AGE 21-10.055

Onderwerp Aanvraag “permanent opslaan van CO₂ in het voorkomen P18-2”

In reactie op uw adviesverzoek over de aanvraag “Permanent opslaan van CO₂ in het voorkomen P18-2” van 12-2-2021 door de aanvragers TAQA Offshore B.V. en EBN CCS B.V. (hierna: de aanvragers) vindt u hierbij ons antwoord.

Figure 2.2 Inline 2025. The thin black line indicates the top reservoir surface, the subhorizontal dashed yellow line indicates the seismic interpretation of the top surface. The subvertical dashed lines are fault interpretations.

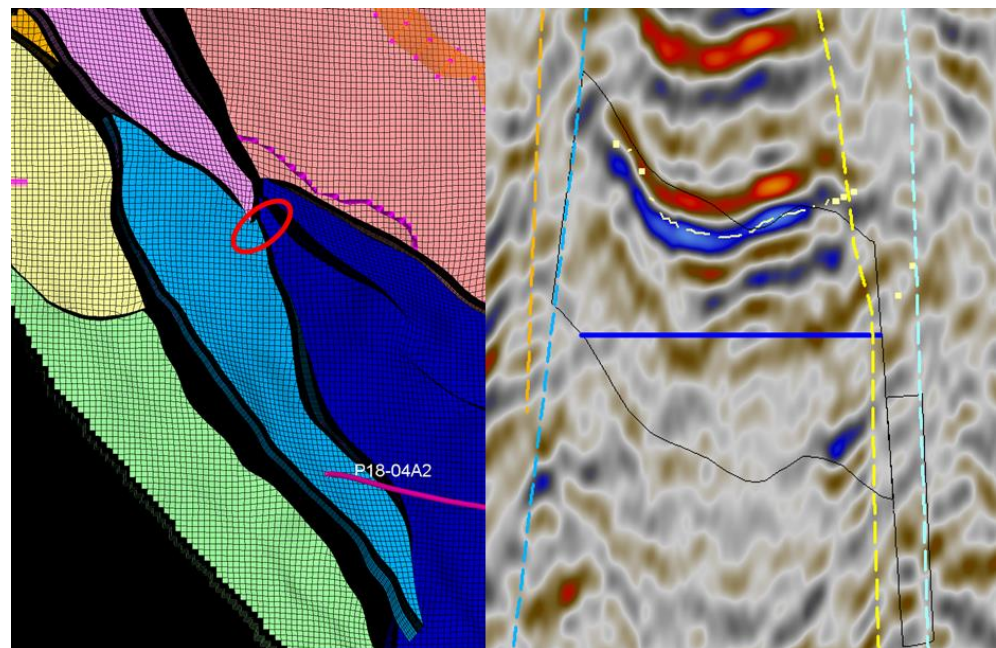
TNO-AGE checked the well-tie of all wells present at the fields with respect to the interpreted and modelled top reservoir and the seismic data. We tested the interpreted and modelled top reservoir that follows the designated seismic wavelet interpreted to be the top Bunter reservoir. Most parts of the modelled area show a reasonable to good match of the seismic data with the interpreted and modelled top reservoir. However, some areas show a significant difference between the modelled top reservoir and the seismic horizon and seismic loop. This has been communicated with the applicant and it seems that numerous stochastic realizations were created of the top reservoir surfaces (pers.comm., 2021). The top reservoir provided by the applicant gave the best fit of the static model GIIP with the dynamic GIIP, and as the applicant deemed this more important the

differences with the seismic data was taken for granted. TNO-AGE understands the applicants' strive for a good fit of the static and dynamic data. However, TNO-AGE does not feel that any difference between static and dynamic volumes are adequately resolved by solely altering the top of the reservoir, as reservoir properties such as thickness, porosity and gas saturation also likely play a part. Additionally the chosen methodology ignores the seismic data largely. The chosen top reservoir model with respect to the seismic data impacts the juxtaposition analysis provided by the applicant in the risk assessment plan. Below we demonstrate some of the observed differences between the interpreted top reservoir, the modelled top reservoir and the seismic data that could lead to additional juxtaposition of the reservoir.

Figure 2.4 Inline 2115. The thin black line indicates the top reservoir surface, the subhorizontal dashed yellow line indicates the seismic interpretation of the top surface. The subvertical dashed lines are fault interpretations.

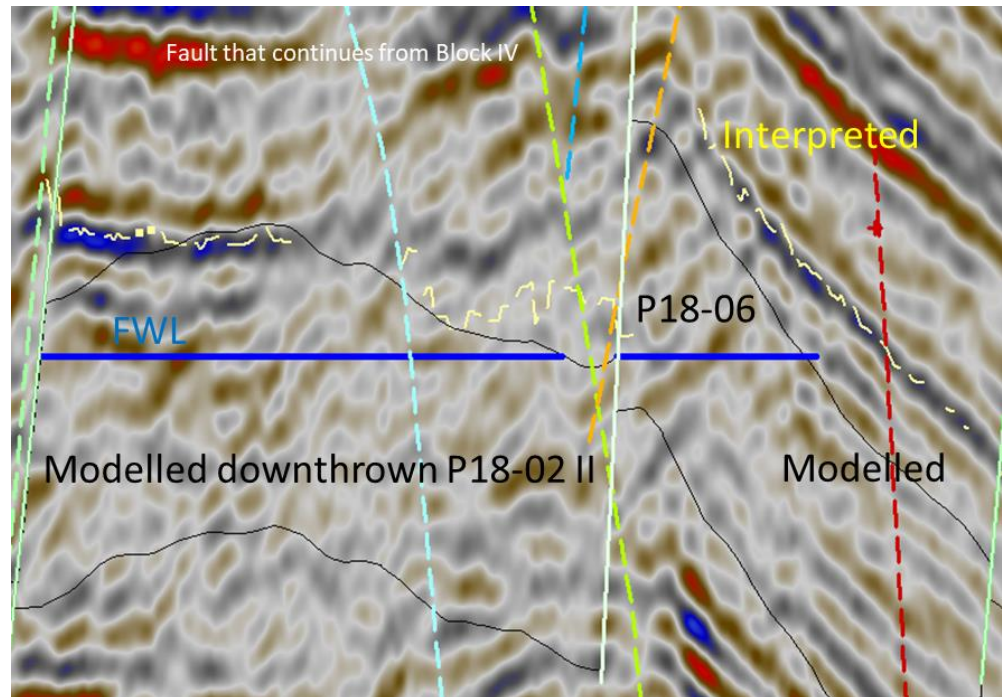
At the P18-6 field there is a very poor well-tie between seismic data, interpretation and the welltop. The modeled top Bunter seems to be corrected for this poor match (Figure 2.3). The adjacent downthrown blocks at a specific distance also suffer from this poor match. The question arises whether picking a different modelled top reservoir could lead to a juxtaposition of reservoir between the P18-6 field and the downthrown block of P18-2 Block II (Figure 2.4).

Figure 2.5 Multiple inlines through block IV and block III. The thin black line indicates the top reservoir surface, the subhorizontal dashed yellow line indicates the seismic interpretation of the top surface. The subvertical dashed lines are fault interpretations.

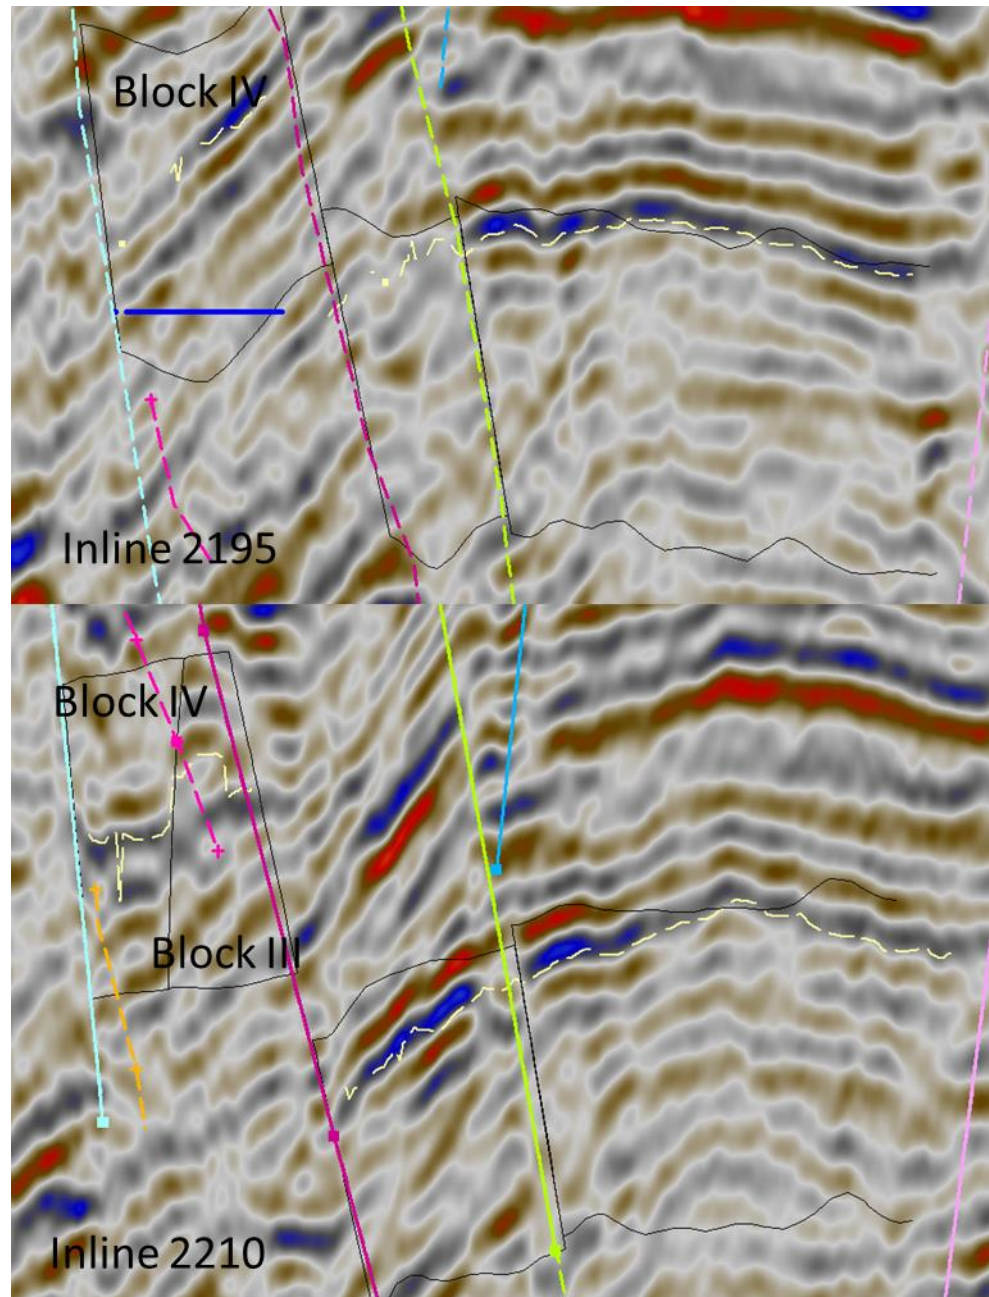
At block IV, the applicant reports a reservoir juxtaposition with the downthrown block. However, when comparing the modeled top reservoir with the seismic data/interpretation, it appears there is a poor match and the modeled reservoir seems to be shallower than the seismic data suggests (Figure 2.5). The downthrown side however, seems to be more in line with the seismic data. If the seismic data is correct, and the model is aligned, it could be that there is juxtaposition of the reservoir with the downthrown block. It is possible that this juxtaposition continues up to the northeastern tip of block III.

Figure 3.1 Numerical reservoir grid block thickness (a) and porosity (b) for vertical cross section J-K number 19.

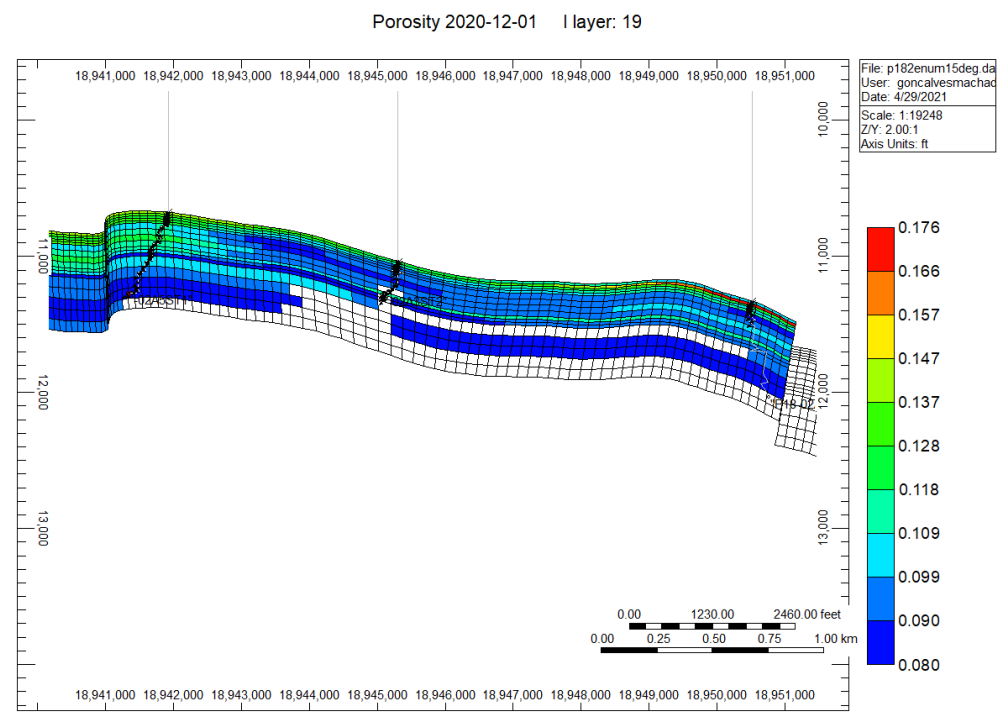
As explained in Chapter 3, the numerical grid used to represent geological properties is much coarser than the geological variations observed in the well logs (centimeters to meters scale, as you can see in Figure 3.1). The model does seem to represent the high-perm streak observed in the upper Hardeggen on an averaged grid level. But given the thin bedded nature of each high perm streak it is not expected that each individual streak is connected away from the wellbore, consequently, influencing CO₂ distribution.

Figure 3.4 Pressure and Temperature at wellbore P18-02A1 grid versus time. If we close all wells after 3 years of injection, it would take around 10 and 20 years for pressure and temperature stabilizing, respectively.

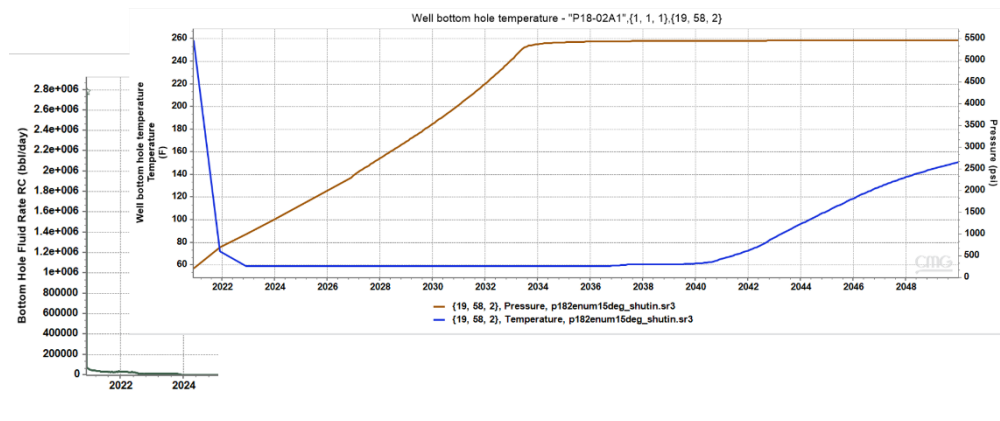
question, how to compute the temperature to be used? As can be seen in Figure 3.4, after shutting the well, would take 20 years for the temperature to stabilize and 10 years for the pressure. This figure was generated by closing all the wells after 3 years of planned CO₂ injection. And this disregards any uncertainty in the thermal modelling.

Figure 7.1 Cross plots of core porosity vs log porosity from BP [5]. Left: core porosity vs neutron-density log porosity, right: core porosity vs density log porosity.

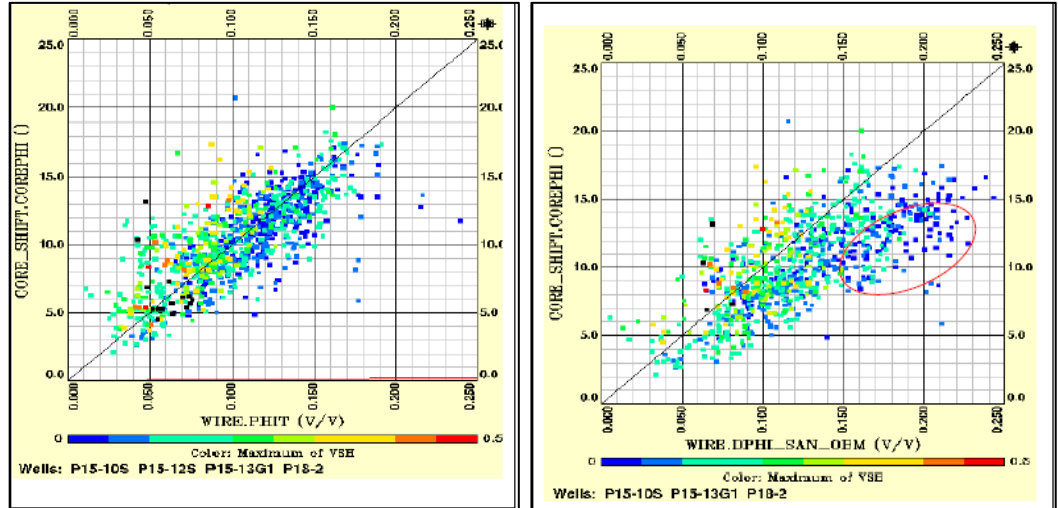
BP has based the porosity calculation on the neutron-density log combination, where available, while AP only uses the density log. BP states that the result of the neutron-density porosity gives a better match with the core porosity, and AP states that the density porosity gives a better match. Both provide cross plots to show the results (Figure 7.1 and Figure 7.2) [4 & 5].

Based on the provided documents and information TNO-AGE cannot explain why the density-neutron porosity is a better match in the study of BP, while the density porosity matches better in the study of AP. Usually, in case of a gas filled reservoir

The porosity calculated by BP has been used to populate the static model. Considering the arguments above and the good match between the log and core porosity of BP, TNO-AGE supports this choice.

Figure 7.4 Overview plot with porosity-permeability transforms from studies of AP [4] and BP [5].

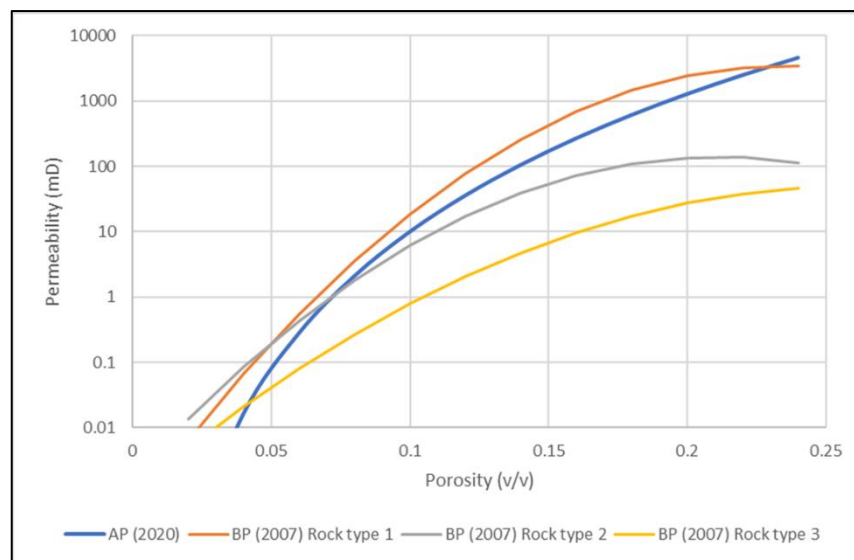
For comparison, TNO-AGE incorporated the poro-perm relationships of BP and AP into a single graph (Figure 7.3). Figure 7.4 shows that the logarithmic relation of AP closely matches the power relation for rock type 1 of BP. The incorporation of the shale content variable in the relation of AP moves the blue line up and down, more

or less between the rock type 1 and 2 lines of BP. This indicates that the porosity-permeability relationships as defined by AP and BP are in very close agreement, especially because the major part of the (net) reservoir interval consists of rock type 1 and 2.

Figure 7.5 Left; core plug porosity-permeability plot with envelope lines defining the uncertainty range [4]. Right; plot of log based permeability vs well test permeability, including envelope lines defining the uncertainty range [4].

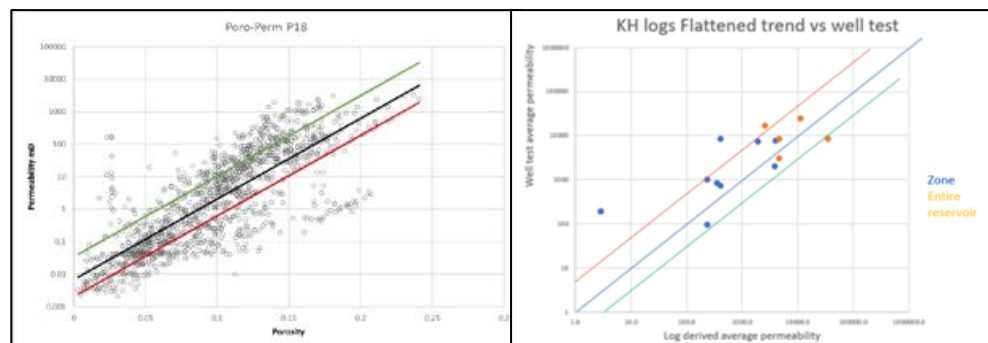
The permeability uncertainty range as applied to the model was 0.3 – 5 times the average permeability. This range is based on the uncertainty from the core plug porosity-permeability plot and the log-based vs well test permeability plot (Figure 7.5).

Because of the scale difference TNO-AGE considers an uncertainty estimation based on a core plug data plot an inadequate approach. However, the uncertainty based on the variation in well test permeability is more adequate and the proposed range also seems appropriate based on the presented data and information.

Figure 7.6 Log based permeability vs well test permeability. Left: without random noise, right: with random noise.

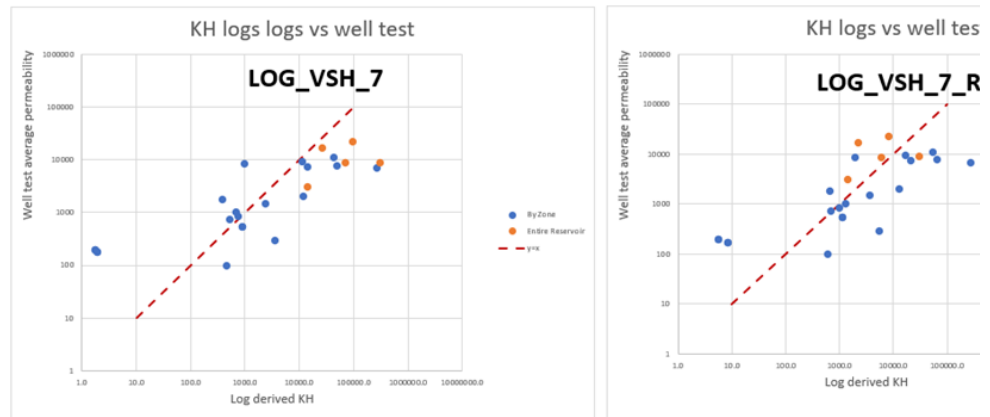
The upscaling of permeability in a static model is a complex problem and often results in a mismatch between the log based permeability and the well test permeability. The arithmetic average is a commonly applied averaging method, but this can result in an average permeability that is 3 to 5 times higher than the well test permeability. The results of the petrophysical analysis by AP also shows a mismatch between the log based permeability and the well test permeability (Figure 7.6).

AP describes three possible solutions for this problem: 1) binning, 2) mathematical (multiplication), 3) adding random noise. Of these three solutions AP considers random noise to be the best option. AP tested this method, but concludes that it does not show a clearly better approximation of the well test permeability (Figure

7.6). However, the relatively large spread in data points in Figure 7.6 makes a comparison difficult. It might be better to do the evaluation per well. TNO-AGE wonders why the option to use geometrical averaging of the log based permeability was not considered and proposes to test this in the model. Especially in eolian reservoirs with limited layering/lamination and relatively random flow through the reservoir, applying the geometrical average can give a better approximation that is closer to the lower well test permeability.

Figure 7.7 (mis)Match between saturation-height model (blue lines) and log based saturation from TNO [2].

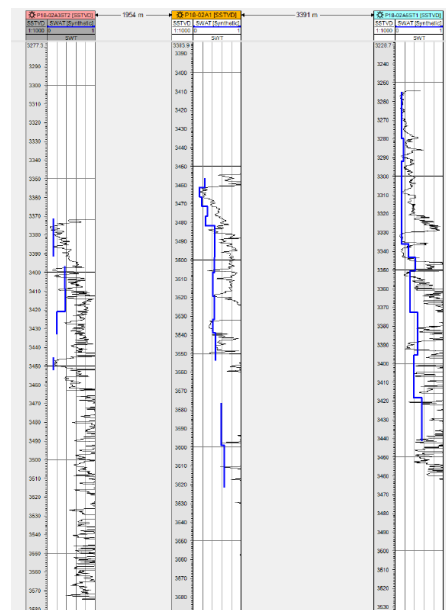
First, TNO [2] defined a lambda model to model the water saturation. The reason to propose a new model instead of using the saturation-height model of BP [5] is not described in the TNO report [2]. It turned out that the lambda model did not result in a satisfactory history match. Therefore, TNO defined a new model based on a J-function, which is eventually applied to the static model. The match of this J-function with the log saturation is less with respect to the lambda model (Figure 7.7), however the calculated static volume matches very well with the dynamic volume. TNO states that the reason for the mismatch with the log saturation is because the logs represent total water saturation. However, TNO-AGE considers the difference as shown in Figure 7.7 to be too large to be solely explained by the total water saturation log.

Figure 8.1 Cumulative Mass of CO₂ plotted against average reservoir pressure. Derived from CLG dynamic modelling results.

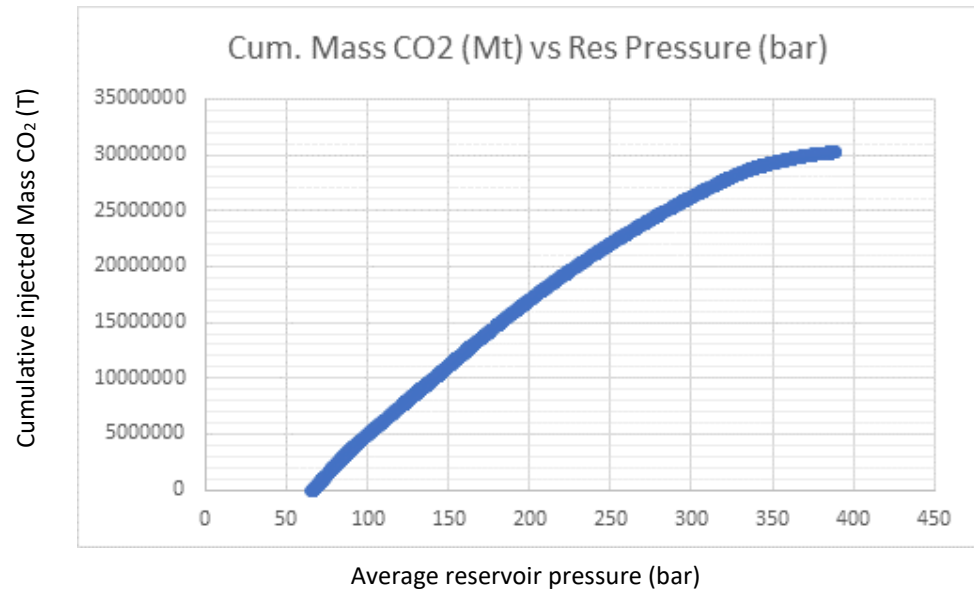
The figure below (Figure 8.1) shows, that the CO₂ mass stored per incremental bar of reservoir pressure strongly declines from 340 bar upwards. In a good approximation this increment is in the order of 1% per 10 bar. The implication of this observation is, that any discussion on a safe maximum fluid pressure limit will have a modest impact on the overall storage efficiency.

TNO-AGE estimates, that the uncertainty on the (future) fluid pressure distribution inside and outside the storage reservoir is likely to be of the same order of magnitude.
